CPSES-200300335  
Log # TXX-03040  
File # 00236

**SUBJECT: COMANCHE PEAK STEAM ELECTRIC STATION (CPSES)**  
**DOCKET NOS. 50-445 AND 50-446**  
**LICENSE AMENDMENT REQUEST (LAR) 02-10**  
**REVISION TO TECHNICAL SPECIFICATION (TS) 3.6.3,**  
**CONTAINMENT ISOLATION VALVES**

**ATTACHMENT 1 to TXX-03040**  
**DESCRIPTION AND ASSESSMENT**

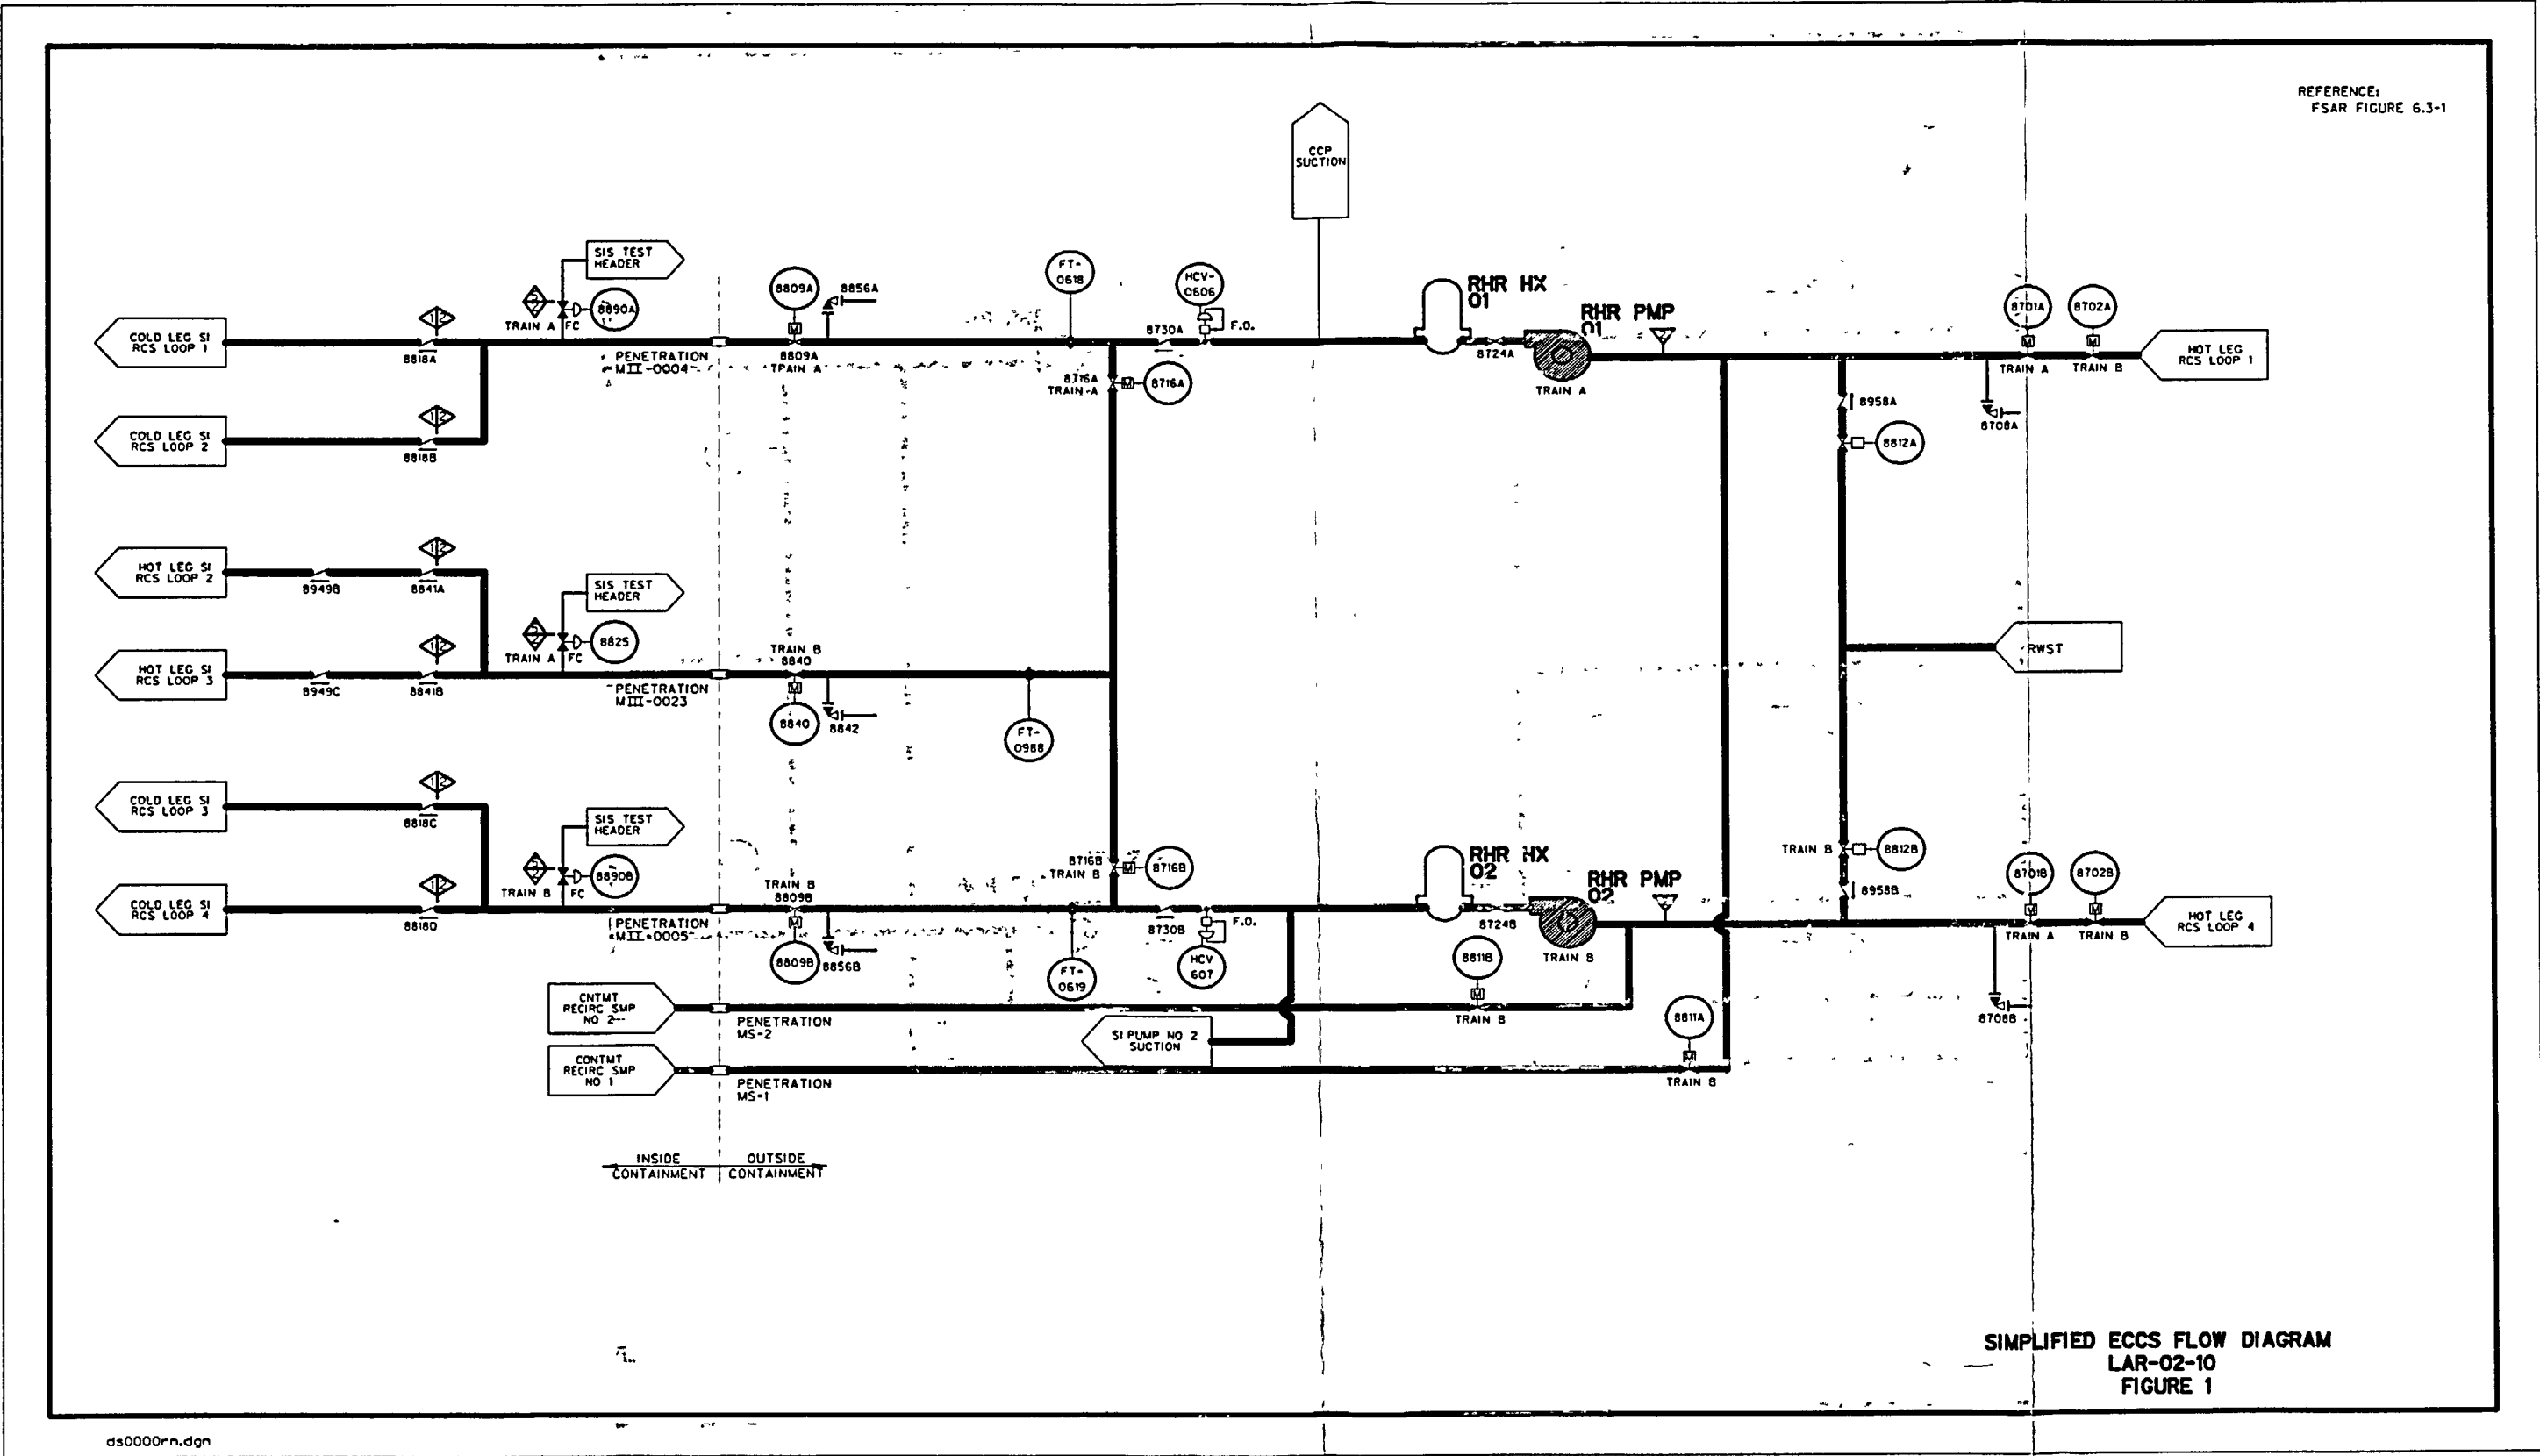
Figure 1 and Figure 2, in Section 4.4 below, show the valve and system arrangement for the Cold and Hot Leg Injection penetrations and Containment Spray penetrations, respectively.

[2] See Figure 1, Section 4.4.

[2] See Figure 1, Section 4.4.

SIMPLIFIED CONTAINMENT SPRAY DIAGRAM  
LAR-02-10  
FIGURE 2

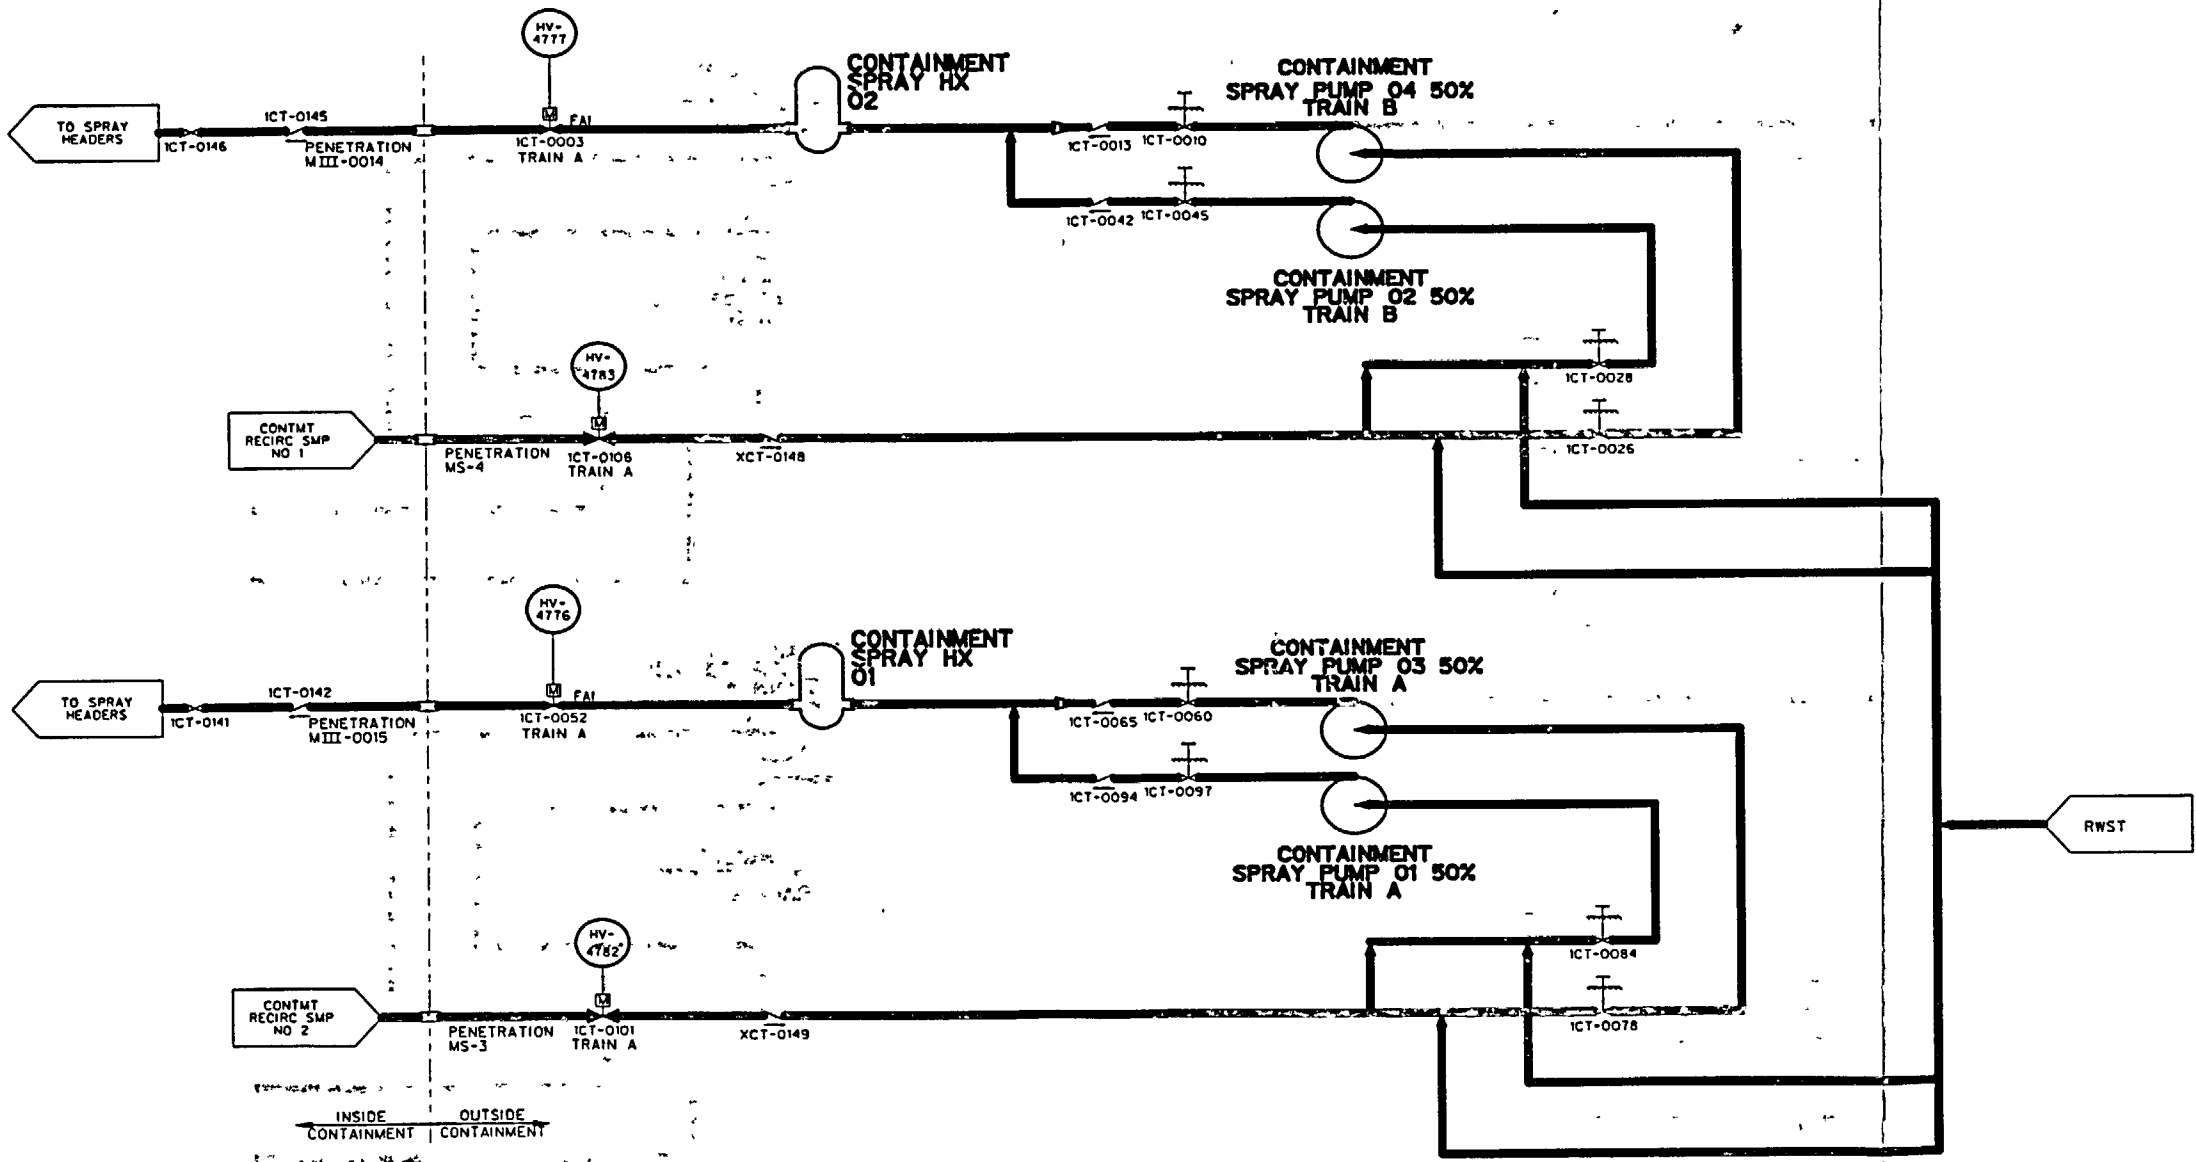
[2] See Figure 2, Section 4.4.
